Addendum 5
TFM-009-24 – GRD-508-23: Concrete & Asphalt Repairs 2024

PROJECT NAME:
CONCRETE AND ASPHALT REPAIRS 2024
Project #: GRD-508-23

Addendum 4
TFM-009-24 – GRD-508-23: Concrete & Asphalt Repairs 2024

COLUMN ELEVATION AND PLAN DETAILS
SCALE: 1:20

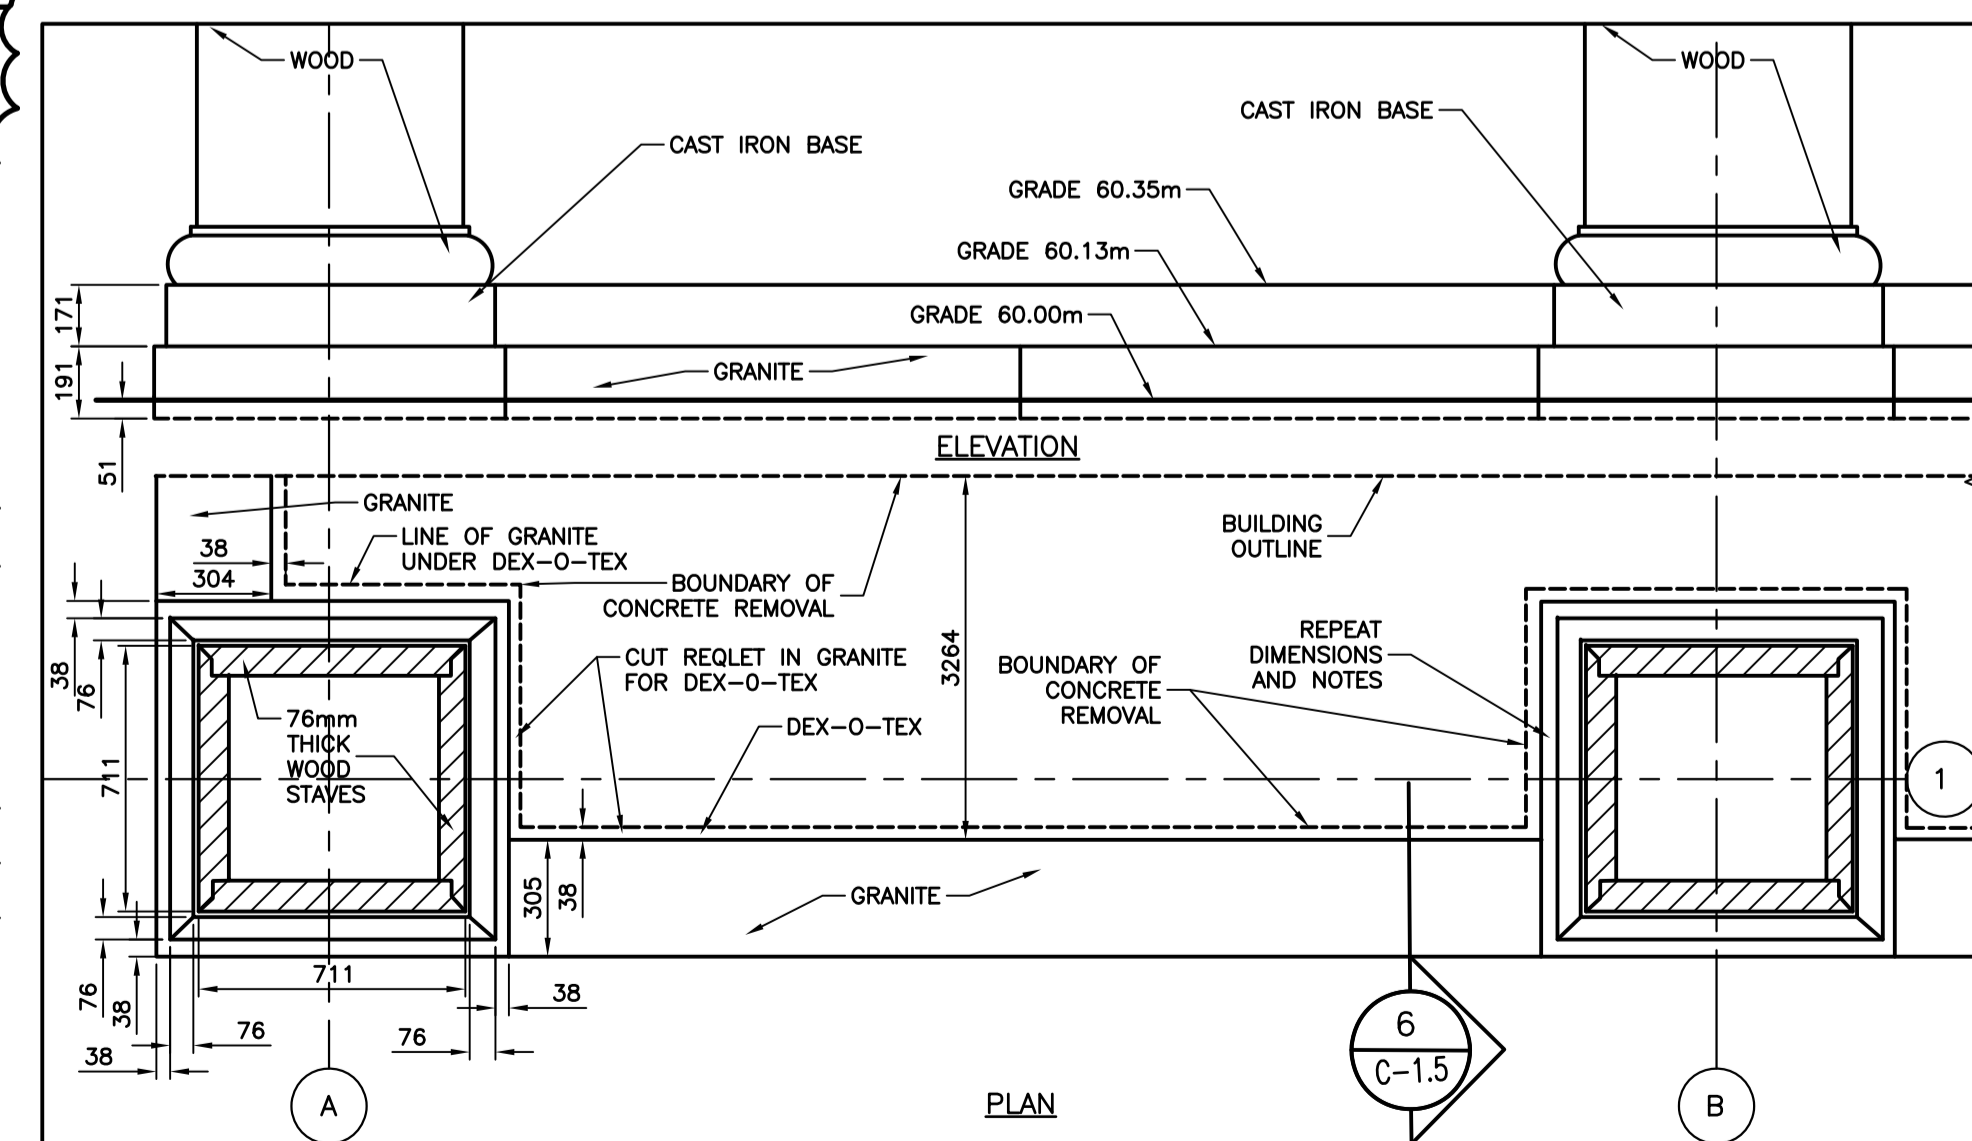
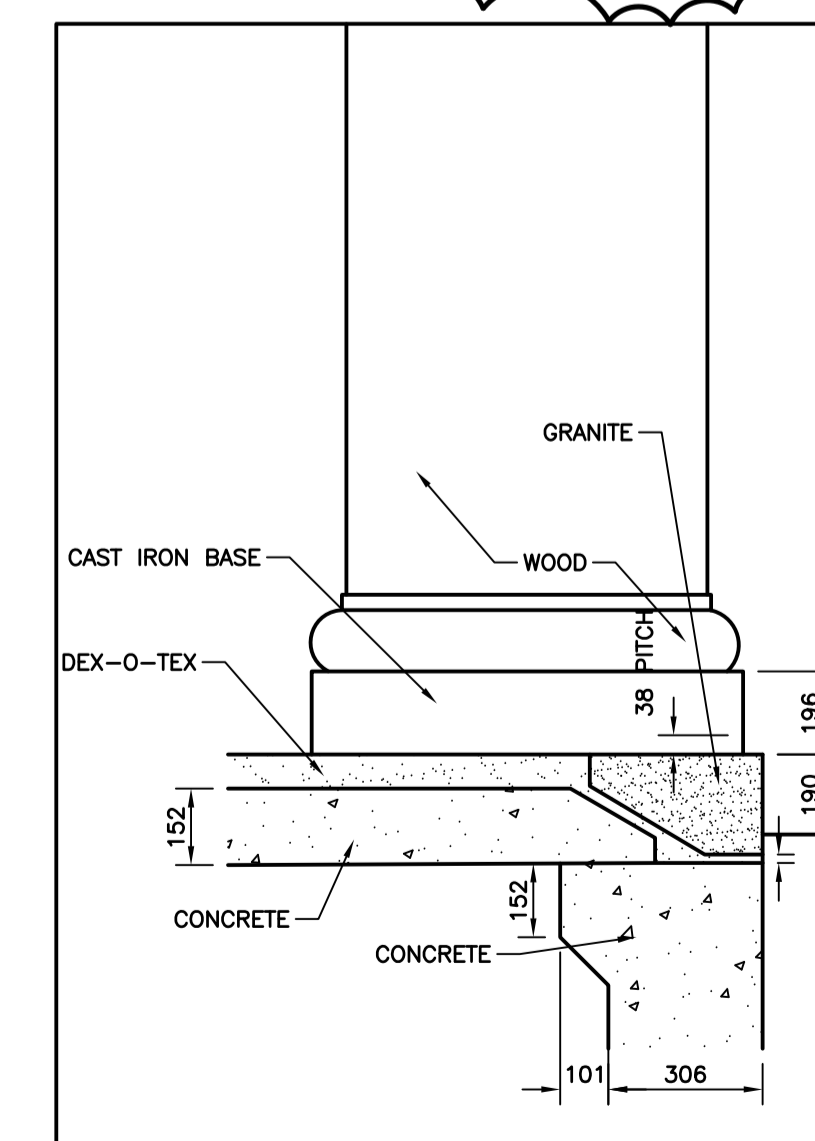
- .16 *Any further detail on the concrete work around the existing columns of the dining hall C-1.5.2. There were other noted materials in this area. Demolition work could be affected. Is the dining hall in service during the summer when work would be completed. The area might require some shrouding.*

RESPONSE: Refer to details 5 & 6 on drawing C-1.5 R1 for more information on the work area and the interface with the columns. Fibre board is to be installed around the inside perimeter of the Main Dining Hall columns, at the interface with the modified slab. The Main Dining Hall is operational throughout the summer. However, during the construction works the south entrance can be closed and alternate entrance, with appropriate signage, can be used. The contractor is required to submit a comprehensive schedule for the scope of works and the owner will facilitate any coordination needed with the users of the area.
